F. A. HESKETH & ASSOCIATES, INC.

MEMORANDUM

Subject: **Engineering Review Appl. #PZC 24-06
East Granby Meadows
Responses to May 30, 2024 Memorandum**

DA-3

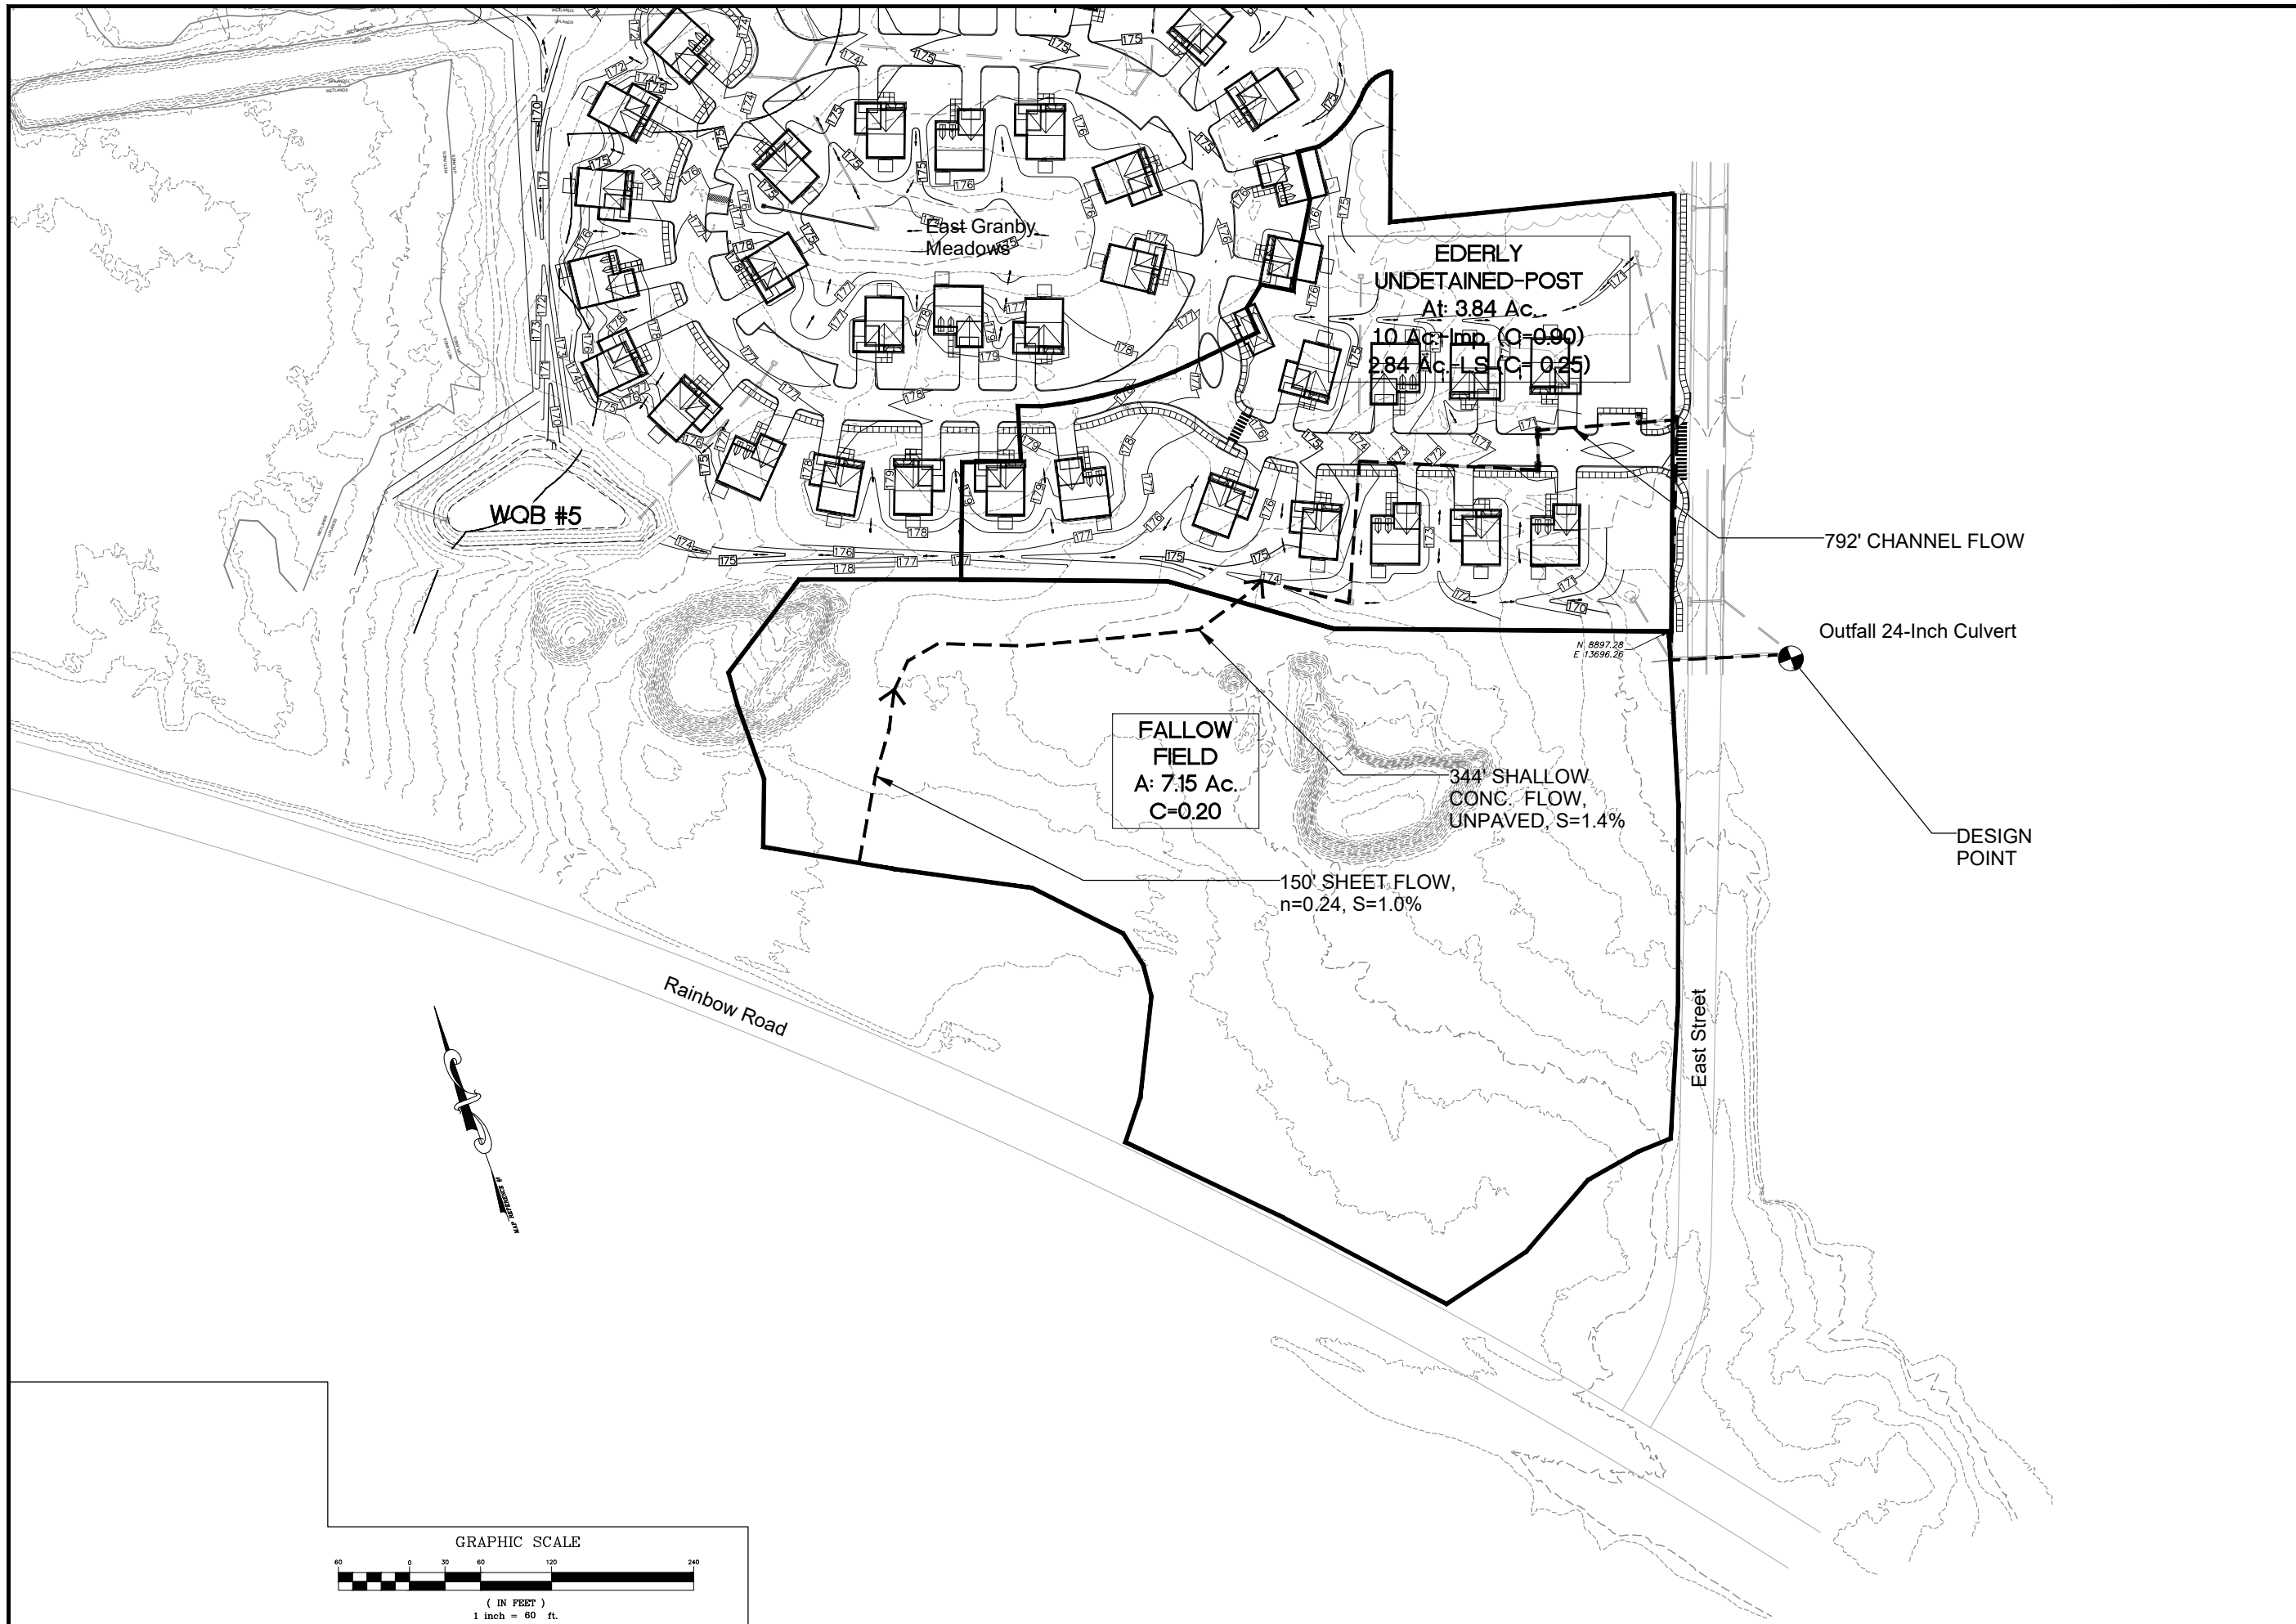
1. Due to the increase in flow within the “Undetained DA”, to the existing East Street culvert of 2.6 CFS, which is a 19% increase at the 25 Yr. Storm Event, please provide a pipe analysis of the existing 24-inch RCP under East Street, which discharges to the east.

A capacity analysis was run on the 24-inch East Street cross culvert that drains the eastern portion of the proposed development. Per the drainage analysis previously submitted, a total of 3.84 acres drains from the proposed East Granby Meadows will drain to this 24-inch cross culvert. In addition, approximately 7.15 acres of the undeveloped lot to the south will also drains into this culvert. The approximate total watershed area draining to the 24-inch culvert is depicted on the attached DA-3.

The drainage areas were estimated using LIDAR topographic data from the CT ECO site for the area between Rainbow Road and the East Granby Meadows project. The total drainage area is estimated to be about 10.99 acres. A weighted runoff coefficient of 0.28 was calculated for the watershed. And a time of concentration of 30 minutes was estimated, using TR-55 methodologies. The analysis shows that for a 25-year storm event, the watershed is anticipated to generate a peak flow of 10.5 CFS, and the 24-inch

culvert has a full flow capacity of 10.0 CFS. The culvert, therefore, has adequate capacity.
